NORTH KERN WATER STORAGE DISTRICT

ADDENDUM NO. 2

SPECIFICATIONS NO. NK 622-623

2018 AND 2020 RETURN CAPACITY PROJECT

88-05-03 WELL CONNECTION

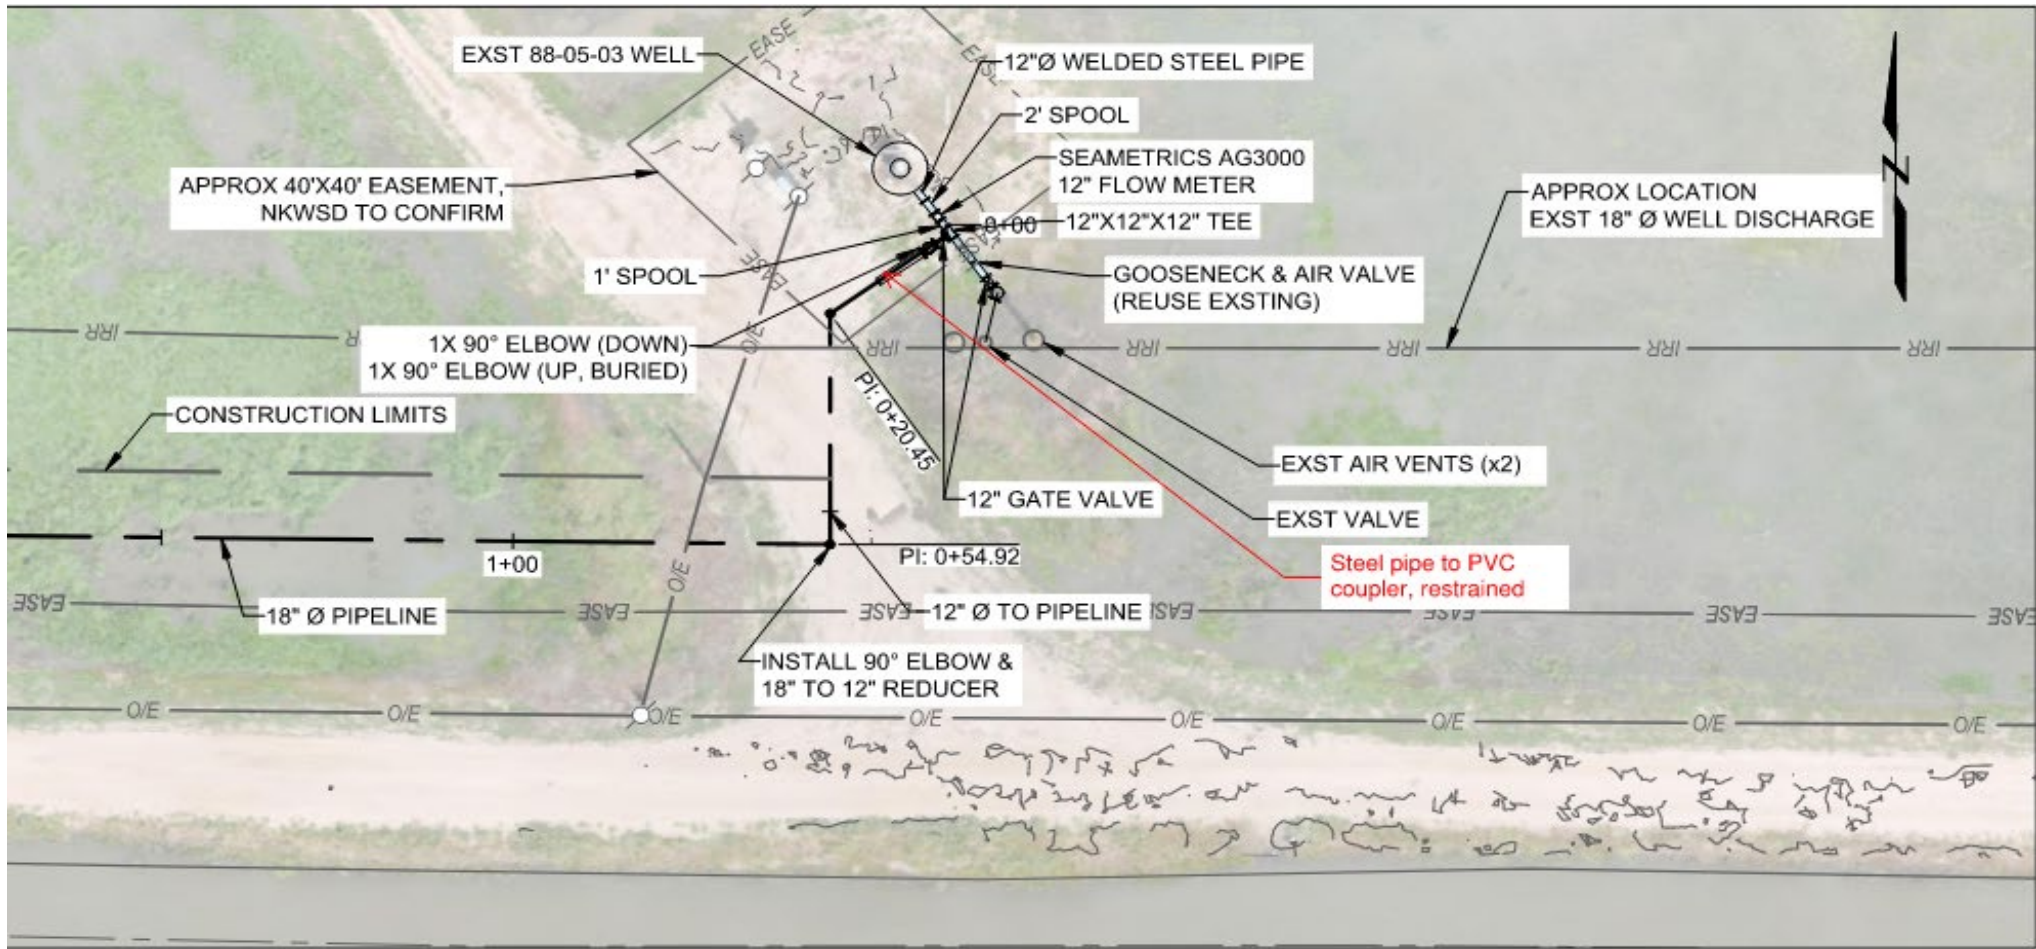
On sheet 15 of 27 of Schedule B Tie in Locations 88-05-03 it does not call out if the 12" pipe to be PVC or Steel. Same for 12" Discharge pipe in 88-29-15 Well Connection Detail. Please Advise.

Are the Steel Lines at the new Well Connection Locations to be FBE L&C as the drawings state? Please clarify?

The pipe shall be welded steel pipe.

The above grade pipelines shall be steel, lined and coated. The below grade pipelines shall be C900 PVC, unless otherwise noted. Well connection 88-29-15 and 88-05-03 below grade pipes connected to the PVC main line shall be C900 PVC. A steel to PVC connector, restrained, shall be installed downstream of the buried steel elbow at both connections. Well connection 88-29-015 below grade pipe that discharges to the canal shall be steel. The drawing will not be re-issued with Addendum no. 2

NO	DATE	ISSUE/REVISION	APP	1	02/29/24	Addendum 2	MM	0				<p>SHEET NAME</p> <p>88-29 WELLS PLAN AND PROFILE STA 0+00 TO 2+04</p>	<p>DWG. NO.</p> <p>CB-01</p> <p>SHEET NO.</p> <p>11 OF 27</p>
NO	DATE	ISSUE/REVISION	APP																
1	02/29/24	Addendum 2	MM																
0

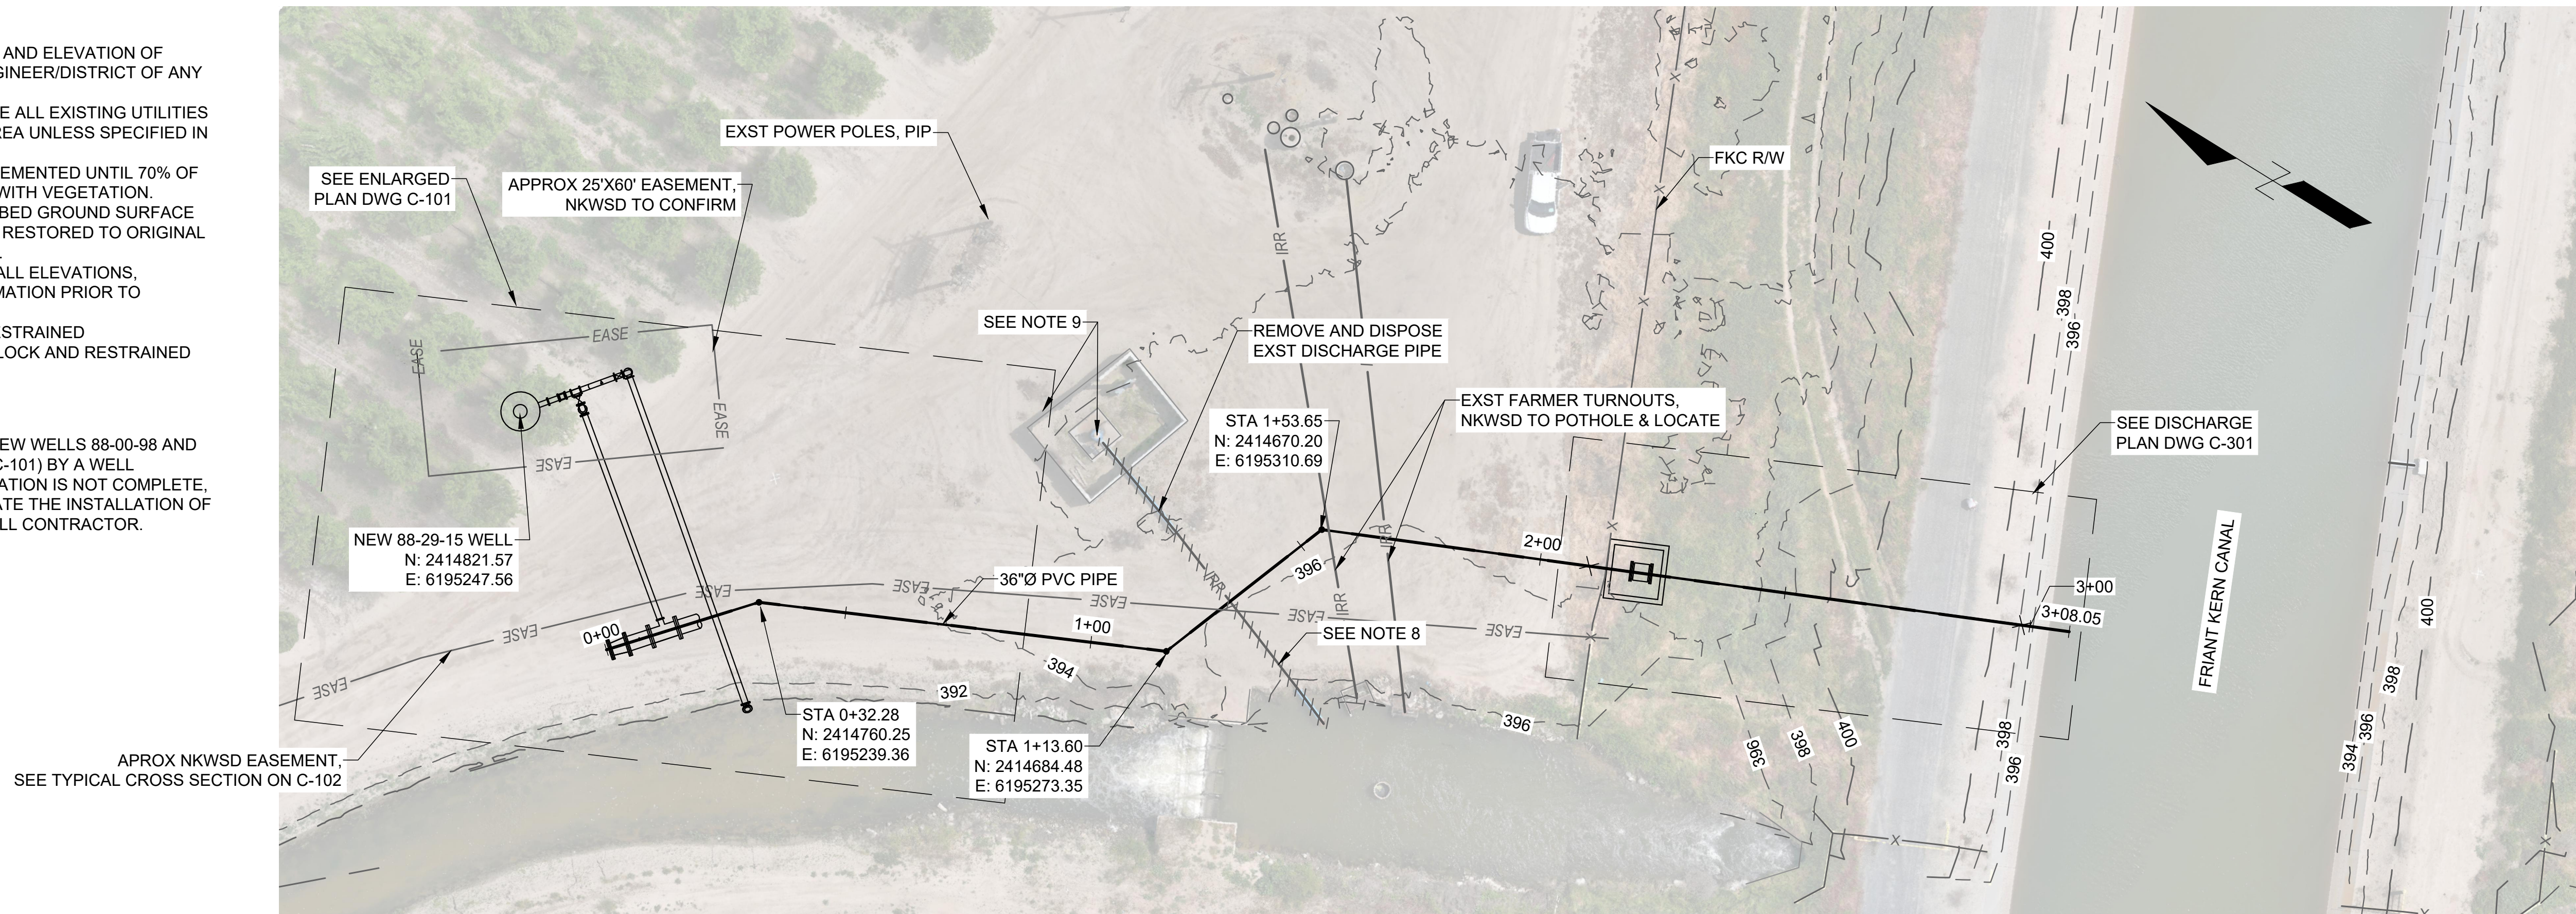
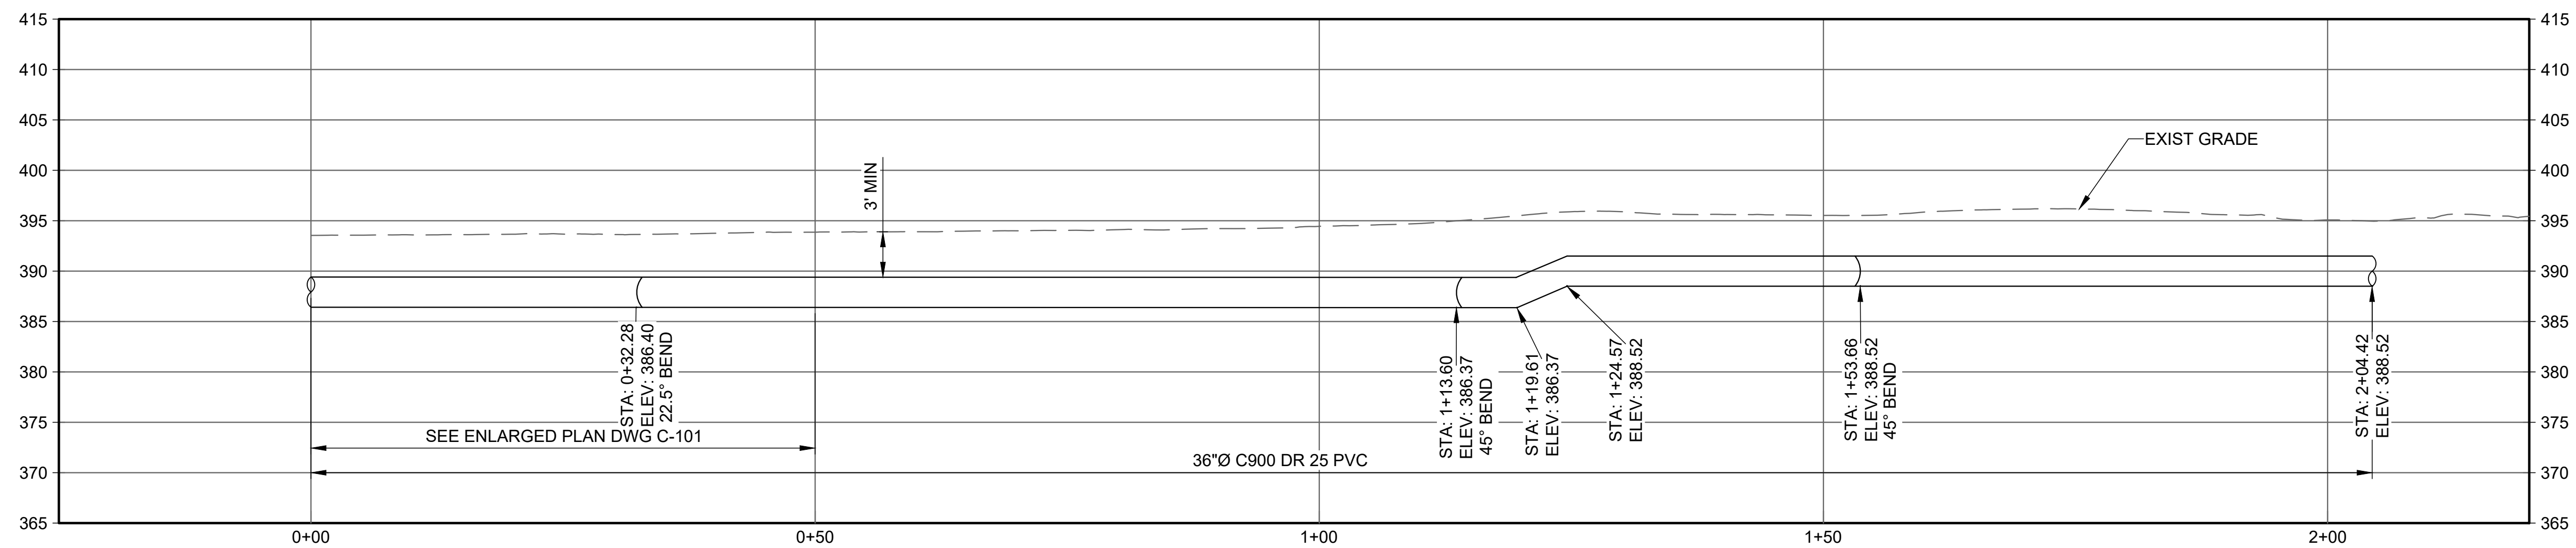
Delete General Notes 8 and 9 and replace with “Not Used”.

Drawing CB-01 has a Note 9. It speaks for Demolishing an existing Pump Enclosure and abandoning the existing Well per Kern County Public Health. - It does not appear that there is a bid item for this in Schedule B? Additionally, is there any more information that can be provided about this pump/enclosure? Please clarify?

Drawing CB-01 has a Note 9. It speaks for Demolishing an existing Pump Enclosure and abandoning the existing Well per Kern County Public Health. It also states to coordinate with PG&E to disconnect and remove existing overhead Electrical Service. - It does not appear that there is a bid item for this in Schedule B? Additionally, is the power currently live to the well? If so, who will be shutting off this power in order to disconnect? Please clarify?

Note 9, on DWG No. CB-01, ("Demolish existing pump enclosure and abandon of the existing well per Kern County Public Health. Coordinate with PG&E to disconnect and remove existing overhead electrical service.") will be removed from the drawing. Note 8, on DWG No. CB-01, ("Remove existing pump piping & electrical and deliver to the District's yard. The contractor may re-use the existing discharge pipe for the new pipe to the 88-29") will be removed from the drawing. The scope of work indicated on both these notes will NOT be part of the contract.

Note 9, on DWG No. CB-01, ("Demolish existing pump enclosure and abandon of the existing well per Kern County Public Health. Coordinate with PG&E to disconnect and remove existing overhead electrical service.") will be removed from the drawing. Note 8, on DWG No. CB-01, ("Remove existing pump piping & electrical and deliver to the District's yard. The contractor may re-use the existing discharge pipe for the new pipe to the 88-29") will be removed from the drawing. The scope of work indicated on both these notes will NOT be part of the contract.
